OVERLOOK AT HOMESTEAD FILING NO. 1

FINAL PLAT

V1_Final Plat Drawings.pdf Markup Summary

DRAWN BY	JWT
CHECKED BY	ERF
H-SCALE	1" = 100'
JOB NO.	2422-00
DATE CREATED	06/05/24
DATE ISSUED	DRAFT
SHEET NO	2 OF 4

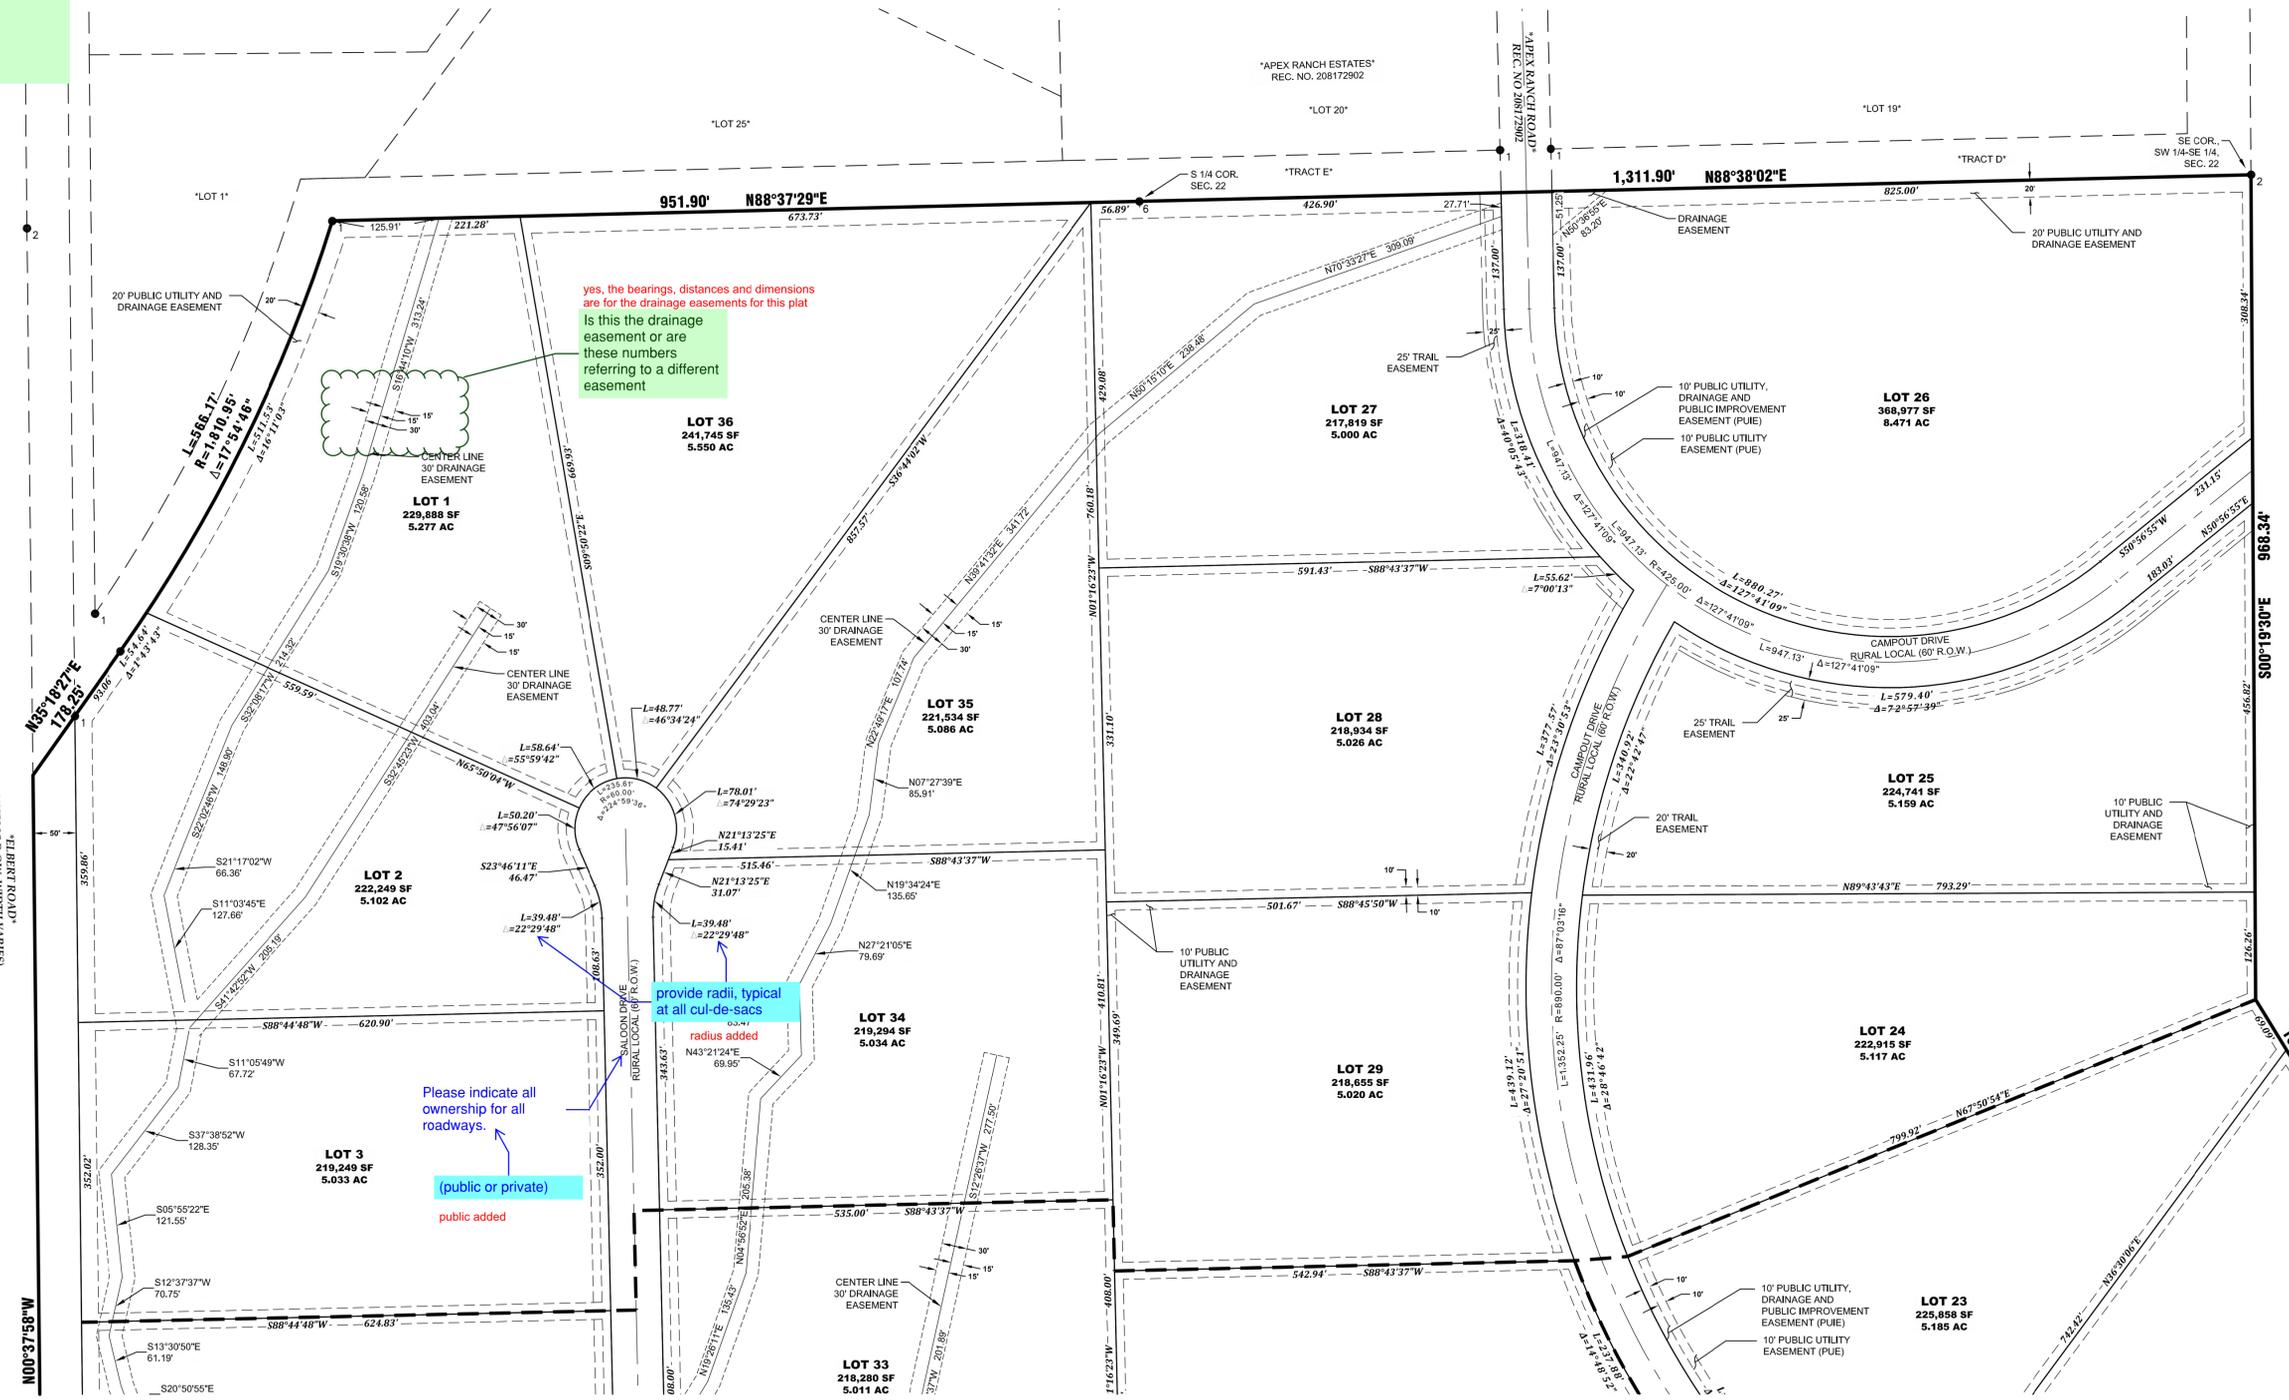
Have not received addresses
 Include addresses from PPRBD

Please provide match lines
 added

yes, the bearings, distances and dimensions are for the drainage easements for this plat
 Is this the drainage easement or are these numbers referring to a different easement

provide radii, typical at all cul-de-sacs
 radius added

Please indicate all ownership for all roadways.
 (public or private)
 public added

DRAWN BY	JWT
CHECKED BY	ERF
H-SCALE	1" = 100'
JOB NO.	2422-00
DATE CREATED	06/05/24
DATE ISSUED	DRAFT
SHEET NO	3 OF 4

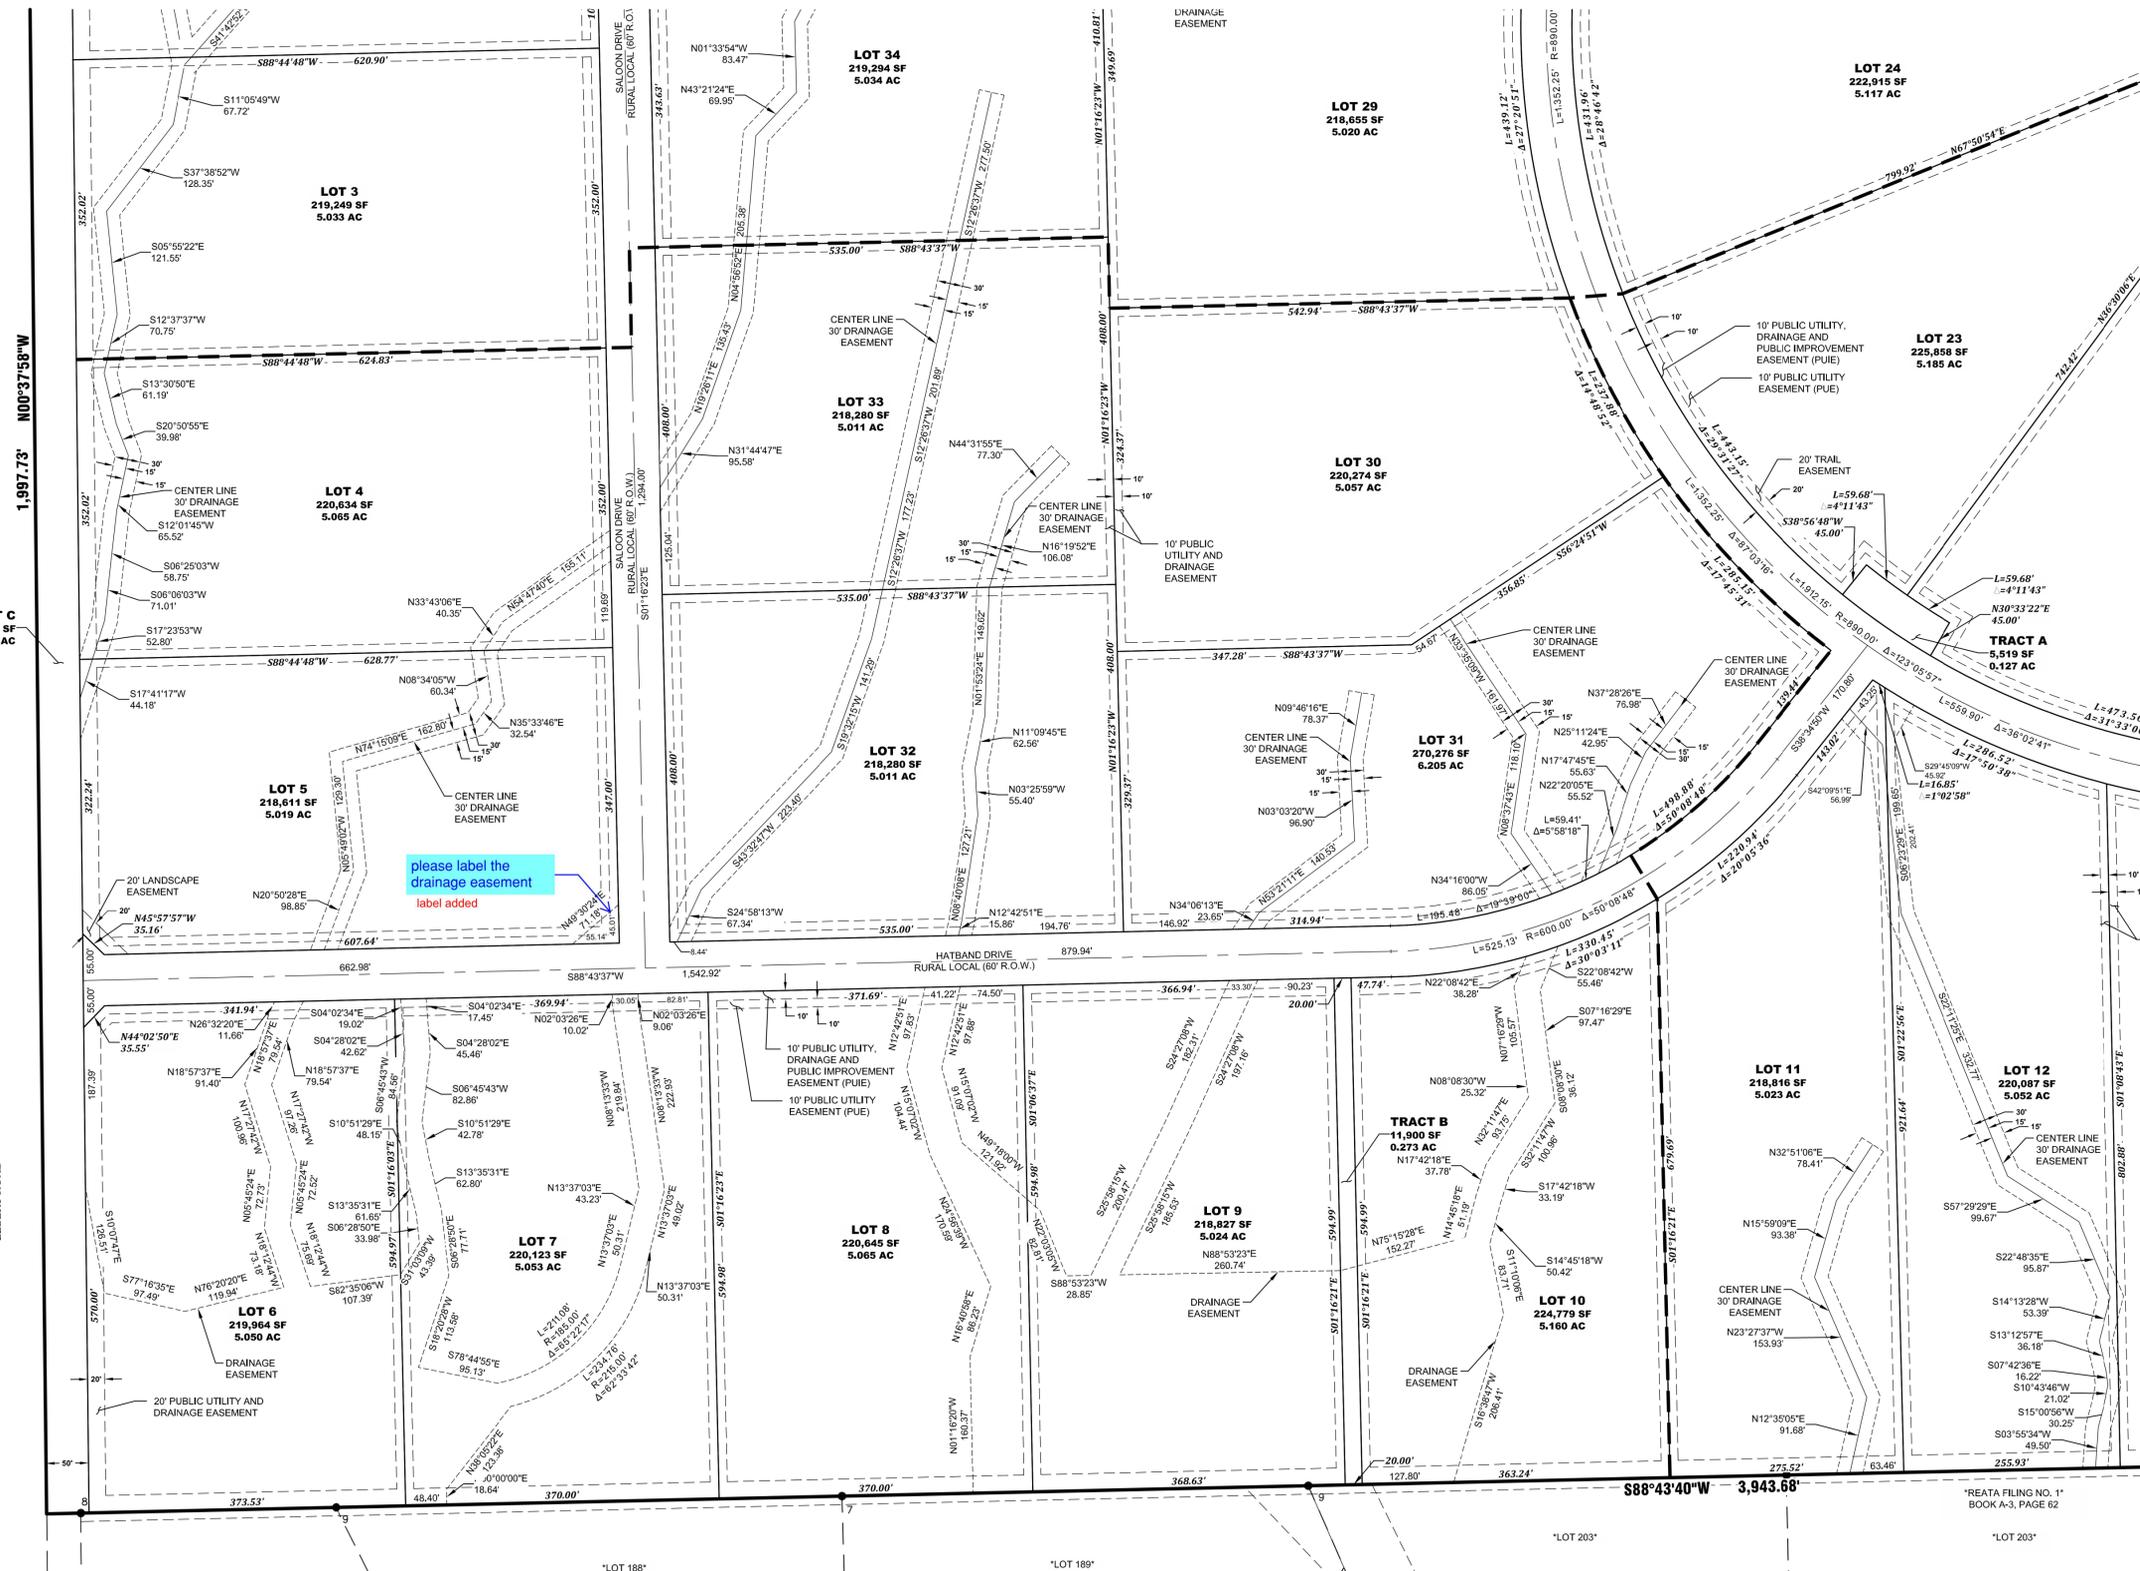
please label the drainage easement

DRAWN BY	JWT
CHECKED BY	ERF
H-SCALE	1" = 100'
JOB NO.	2422-00
DATE CREATED	06/05/24
DATE ISSUED	DRAFT
SHEET NO	4 OF 4

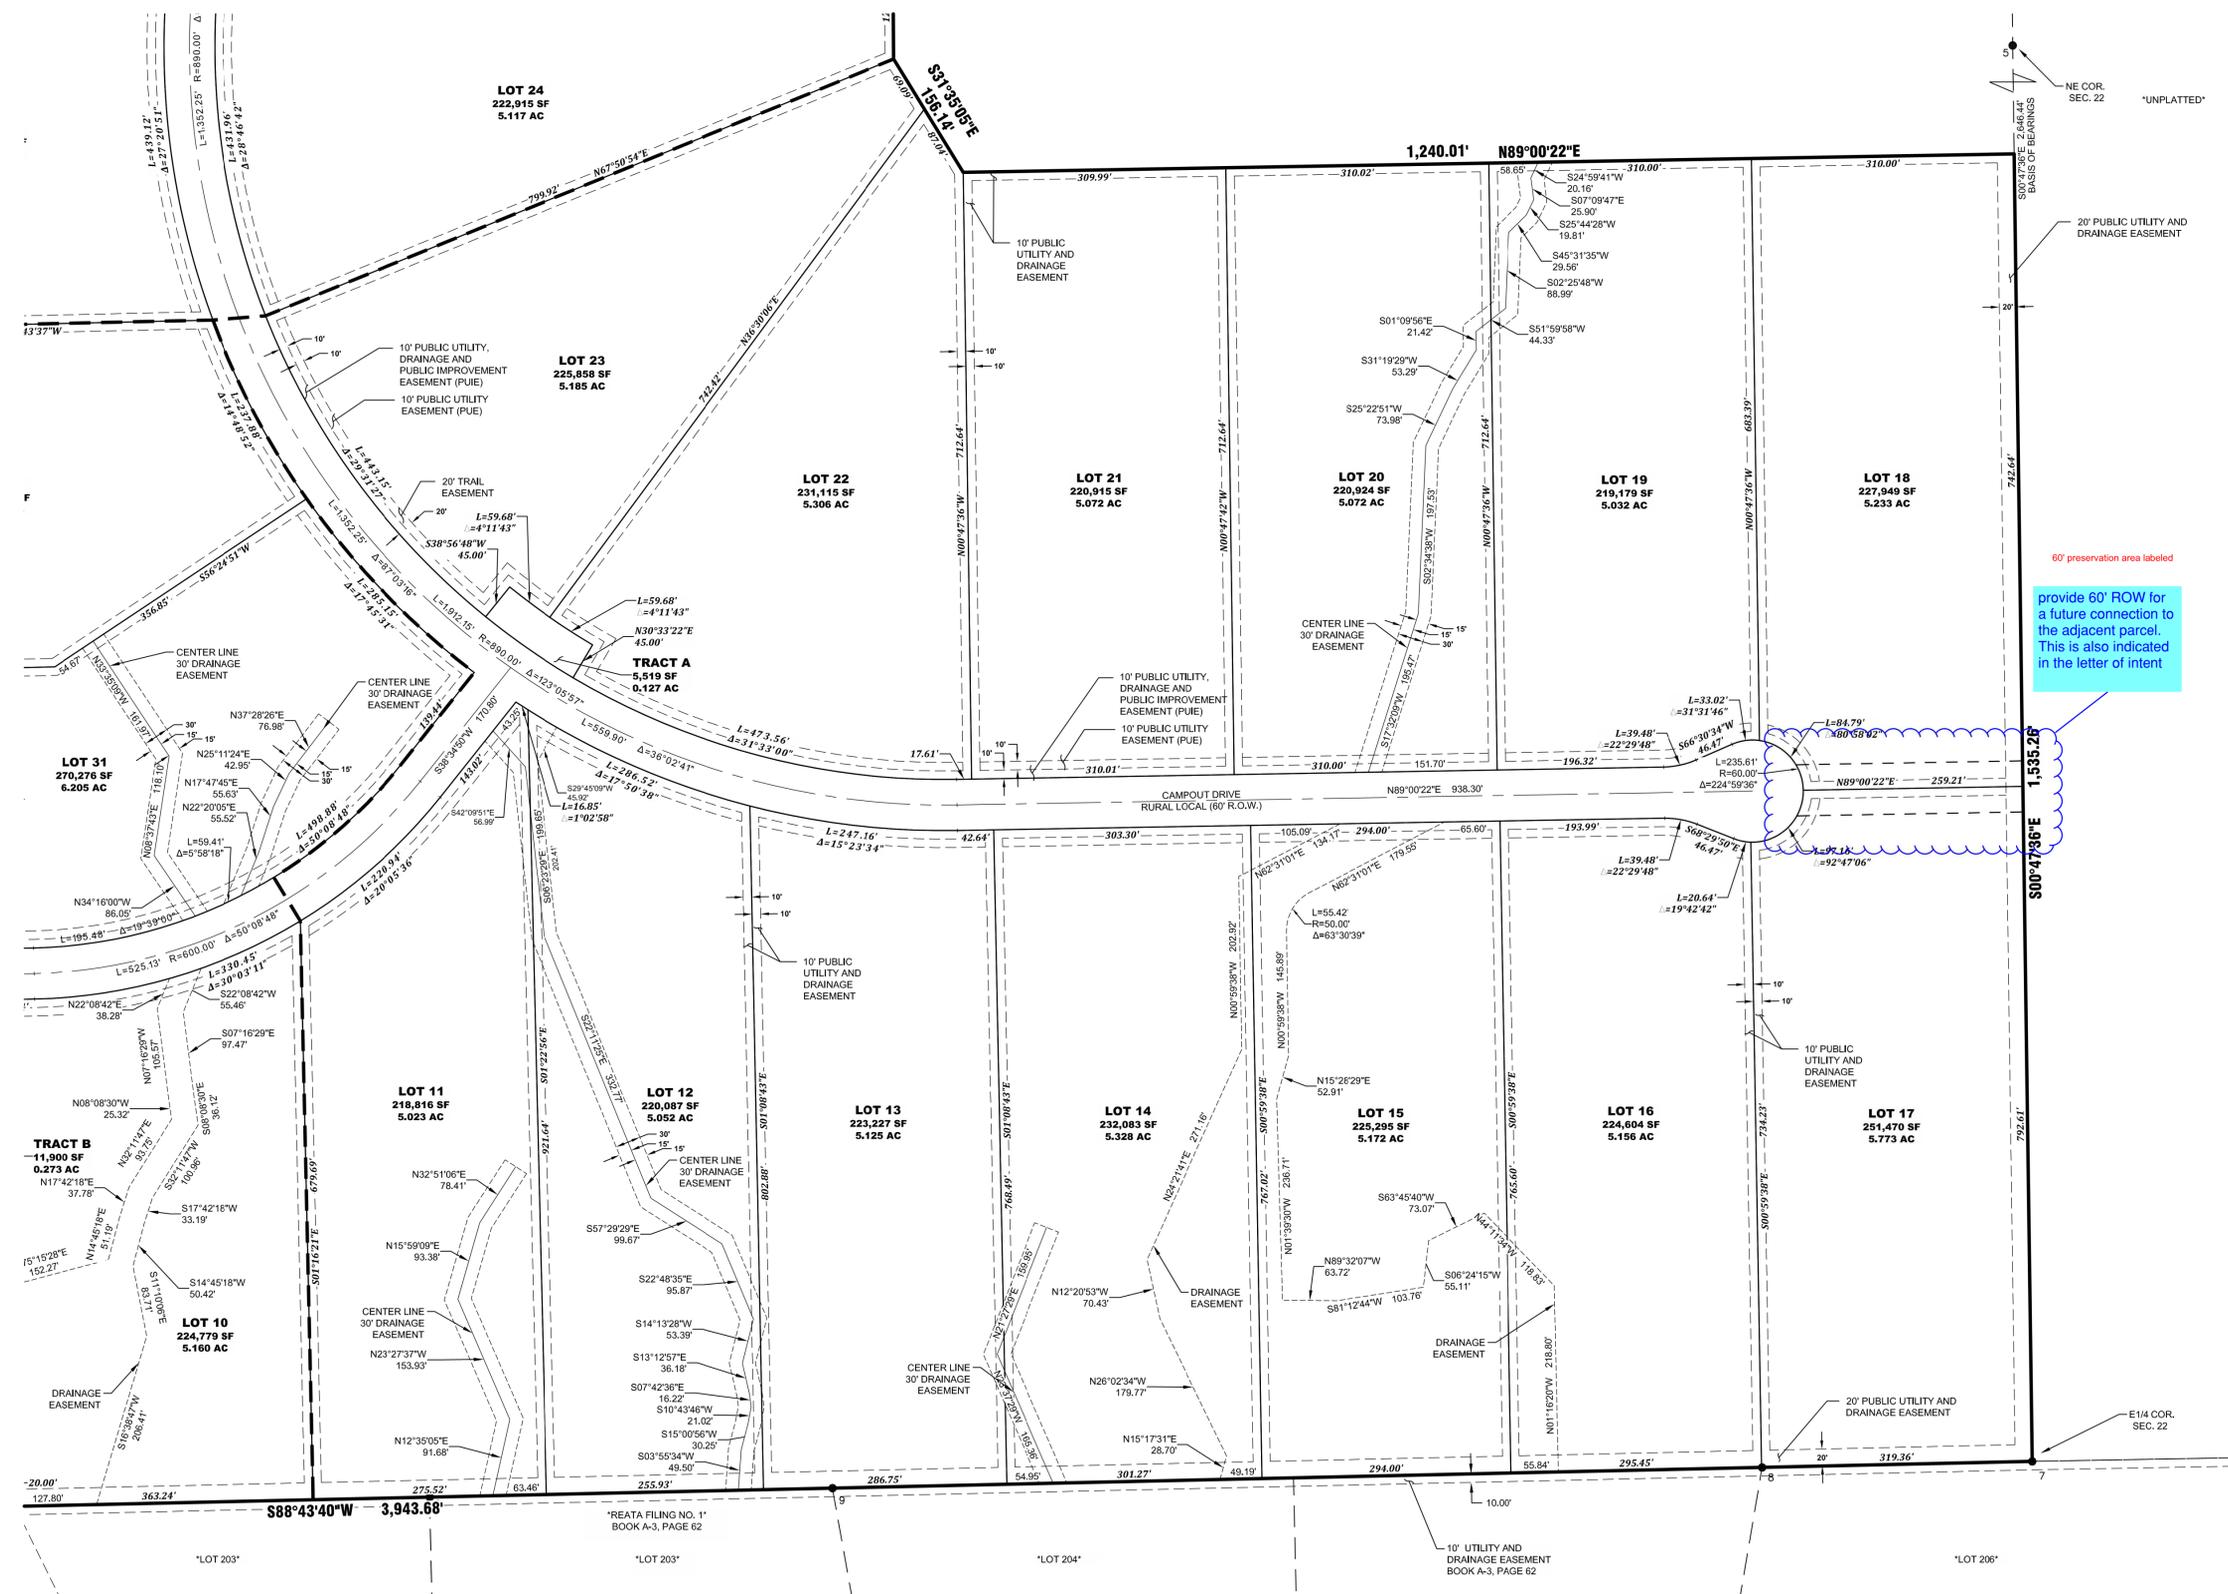
60' preservation area labeled
provide 60' ROW for a future connection to the adjacent parcel. This is also indicated in the letter of intent

Adjacent owner objected during public hearings multiple times.

preservation easement shown and note added
